UNITED STATES PATENT AND TRADEMARK OFFICE

10/553,470

DETAILED ACTION

Claim Rejections - 35 USC § 103

FIG. 15

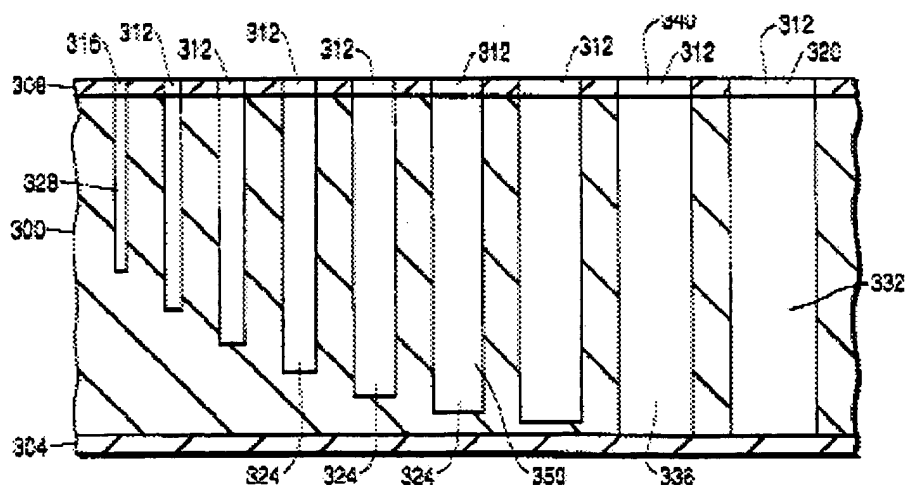
5. As for claims 1 – 3, 5 – 6, 9 – 10, and 14, 17, 20 Hsiao discloses (Col 6 line 36 – Col 8 line 24) and shows in Fig 15 a device and method of manufacturing a semiconductor structure utilizing aspect ratio dependent etching comprising:

a. forming a test structure (Fig 15), defined by a systematic row of a plurality of trenches (324, 328, 336) having different widths and different depths in a defined manner, in an active wafer (300), said wafer receiving an active circuit (148, 178, 198, 222, 202) in a later stage;

i. wherein the deep trenches are formed in a etch process using an etch mask (308) having openings of different widths for the trenches of different widths (Claim 2 – 3);

b. wherein a targeted thickness of the active wafer (2) during the removal corresponds to a depth of a reference trench (350) of the trenches of the test structure, said reference trench (350) being flanked by shallower and deeper trenches, in particular by a neighboring shallower and a neighboring deeper trench (328,336);

18. As for claims 4, 11, and 21, Hsiao shows in Fig 15 the trenches are open and unfill.

19. As for claims 7 – 8, 12 – 13, 15 – 16, and 18 - 19, Hsiao discloses (Col 6 line 59 – Col 7 line 31) and shows in Fig. 15 the composition of the trenches to be a series of stripe-like shape trenches which are parallel in a continuously shallower or deeper series with increasing widths openings, wherein the trenches are more broader the more deeply they are formed. Also, Hsiao discloses (Col 6 line 59 – Col 7 line 50) and

shows in Fig. 15 that the reference trench (350) (applicant's predefined target thickness) is located in a central region of the structure with trenches on one side with openings of smaller width and smaller depth and trenches on the other side with openings of greater width and greater depth. and that depth increases as the corresponding width increases in the structure

FIG. 2G

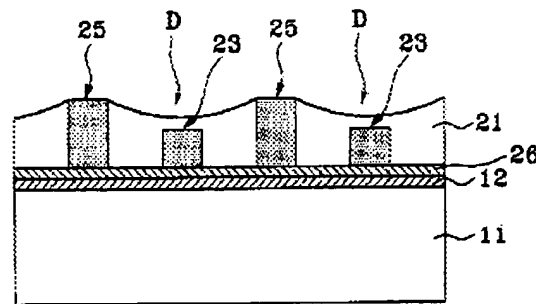
7. So discloses (Col 2 line 66 – Col 4 line 51) and shows in Fig. 2A – 2I a device and a method of manufacturing a semiconductor wafer comprising:
- c. forming a structure in an active wafer made of a silicon wafer (21) with a plurality of different trenches with different depths (22,24) including a reference trench (24);

- d. performing the wafer material removal process comprising a polishing process, commencing from the backside of the active wafer (21) until the reference trench (24) is exposed;

- ii. wherein the polishing process is interrupted at least once (So discloses a two step polishing process (Col 4 lines 9 – 30)) (Claim 9 and 14).
 - e. bonding the active wafer (21) with a side, in which the test structure is formed, onto the second wafer of the semiconductor wafer pair, in particular onto a second wafer (applicant's carrier wafer claim 17) (30) comprising silicon and oxide layers, and;

f. forming an active circuit in said active wafer in said later step (Col. 4, lines 25 – 27).
